INDESIT company

L63EU

F029544

2210130 Exploded views

N1045072FIG1

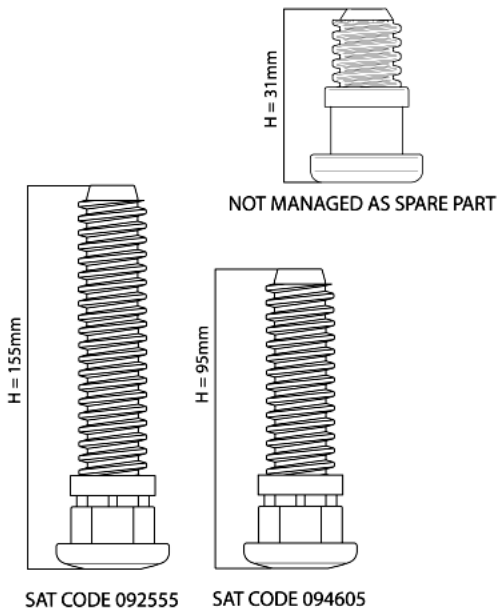
N1045072: Introduction of fixed rear foot H=31mm on free-standing models.

From serial no. 40218.0001, free-standing dishwashers affected by this modification have been equipped with new fixed rear feet (H=31mm).
The new foot replaces the adjustable one (H=155mm) Service code 092555; on the EVO3 range with TurboDry the new foot replaces the adjustable foot (H=95mm) Service code 094605.
The Spare Part Warehouse will continue to manage only 155mm and 95mm adjustable feet as they are interchangeable with the fixed 31mm foot.
The three feet are shown in illustration N1045072FIG1.

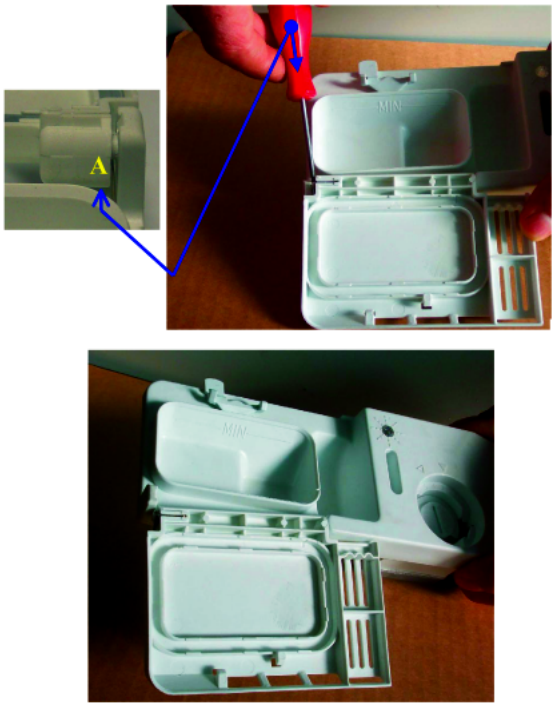
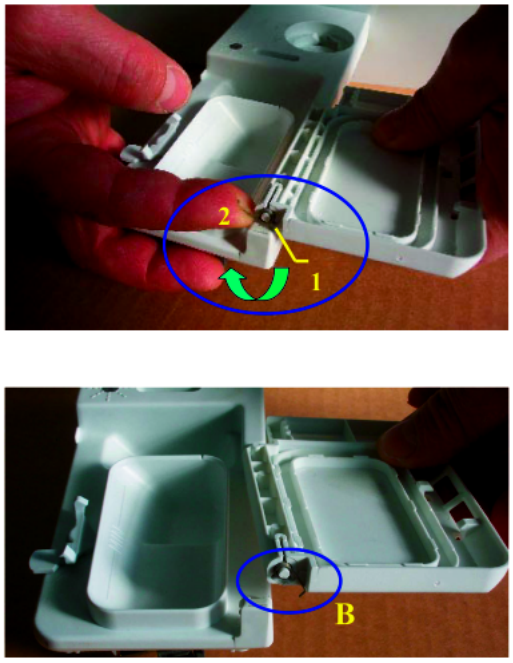
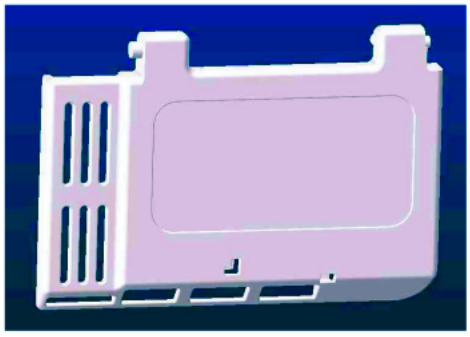
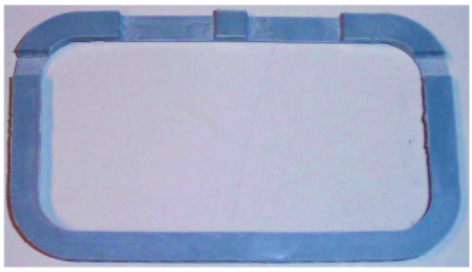
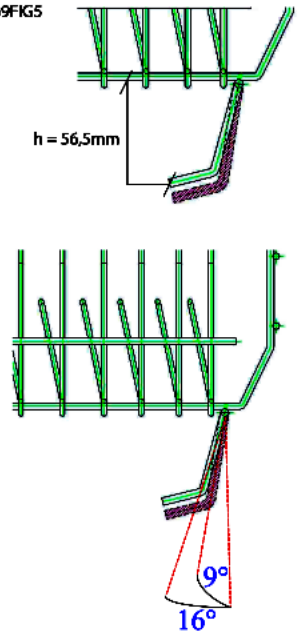
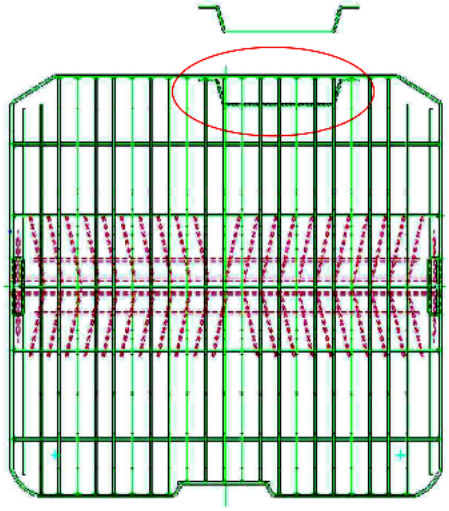
n1045069: Modification of racks and dispenser lid on EVO3 dishwashers

To obtain better dissolving of the detergent during the wash cycle, the following modifications have been made to EVO3 dishwashers:
- new dispenser lid, replacement code 098134 (see figure N1045069FIG4) created;
- upper racks modified with lid catch angle changed from 9° to 16° (see figure N1045069FIG5);
- MultiSystem lower racks modified with insertion of a spacer wire at the electric dispenser (see figure N1045069FIG6).

Lid installation instructions:
1) prise the lid out of the dispenser seat using a small screwdriver at point A (figure N1045069FIG1);
2) replace the lid, checking that release spring B (figure N1045069FIG2) is in place; before fitting the new lid load the spring from position 1 to position 2 (figure N1045069FIG2);
3) fit the lid in its special seat and check for correct operation (figure N1045069FIG3).
Lid closing may be harder for the first few cycles after replacement, due to settling of the material.

N1045083FIG1

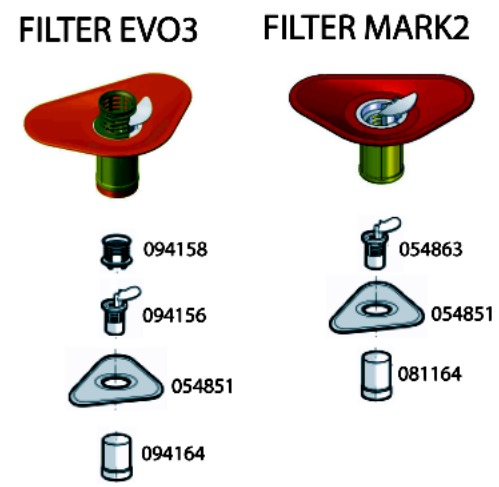
n1045083: Modification of filters on EVO3 60 cm dishwashers

All dishwasher models affected by this modification have been equipped with the items listed below, in order to solve the drain pump clooging problem.

Introduction of:
Cylindrical plastic filter code 081164
Central filter code 054863

Elimination of:

Cylindrical plastic filter code 094164
Central filter code 094156
Central filter grid code 094158

The modification has been introduced progressively, starting from serial no. 40516.0001.

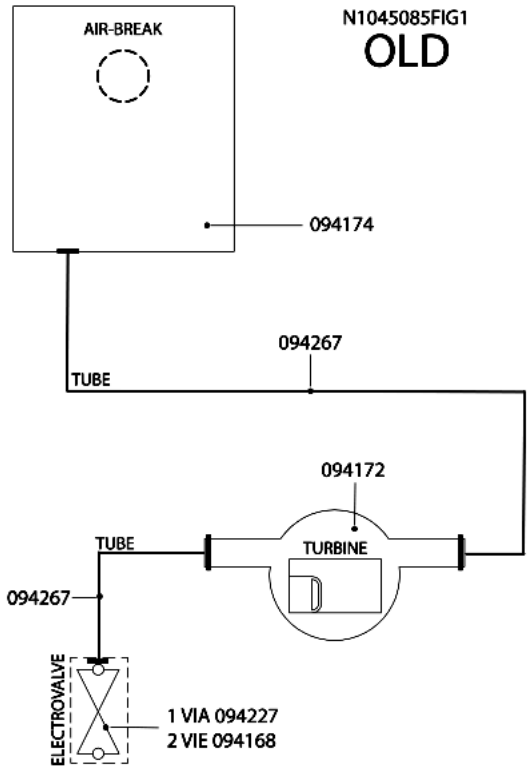
n1045085: Introduction of new litre counter turbine integrated on air-break.

All dishwashers affected by this note have been equipped with a new litre counter turbine on the air-break.
Picture N1045085FIG1 illustrates the premodification structure, picture N1045085FIG2 the new structure.

AIR-BREAK:
new 110610;
premodification 094174;
the new item features a new integrated litre counter turbine and its water supply hose has a smaller diameter.

SOLENOID VALVES:
new:
1-WAY code 110611;
2-WAY code 084558(Rohs 143737);
premodification:
1-WAY code 094227;
2-WAY code 094168;
the new solenoid valves have a smaller diameter drain hose fitting.

HOSES:
new solenoid valve hose/air-break code 110612;
premodification turbine hose/air-break code 094267;
premodification solenoid valve hose/air-break code 094267;
the new hose has a smaller internal diameter.

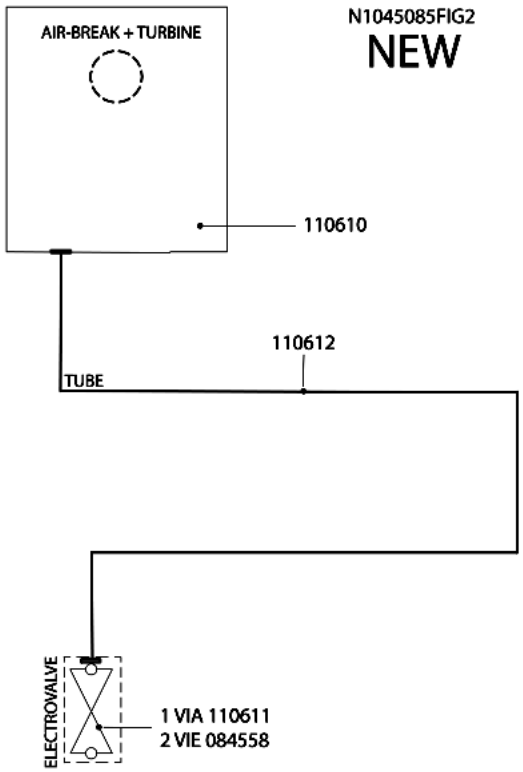
n1045127: New airbreak - solution of water spurts leaking from base LVS 60 CM

From serial number 50930.0001, to solve the problem of water spurts emitted from the lower right and left side of the door the following modifications were introduced in production:

1-Airbreak without insert to allow the necessary pressure venting
2-Honeycomb top panel to protect the kitchen unit from any steam emitted (only on built-under models)
3-Tank seal length increased by 3 cm to improve water tightness
4-Die-cut roof sound-deadening panel
5-Three clips for correct fixing of the tank base seal (in production from serial number 50701.0001)

1) AIRBREAK REPLACEMENT
It is mandatory to use the new part; in the event of replacement with premodification appliances proceed as follows:
- replace the airbreak with the new part C00141308
- if present, refit the roof sound-deadening panel after cutting out a 10x10 cm square from the rear left-hand corner
- on the built-under version, fit honeycomb panel C00141310 on the top of the appliance
- replace tank seal with the new seal P/N C00141317

2) CHANGING THE TANK SEAL
On appliances with serial number from 40101.0001 to 50930.0001, you can use the new tank seal P/N C00141317 after cutting 1.5 cm off each end.
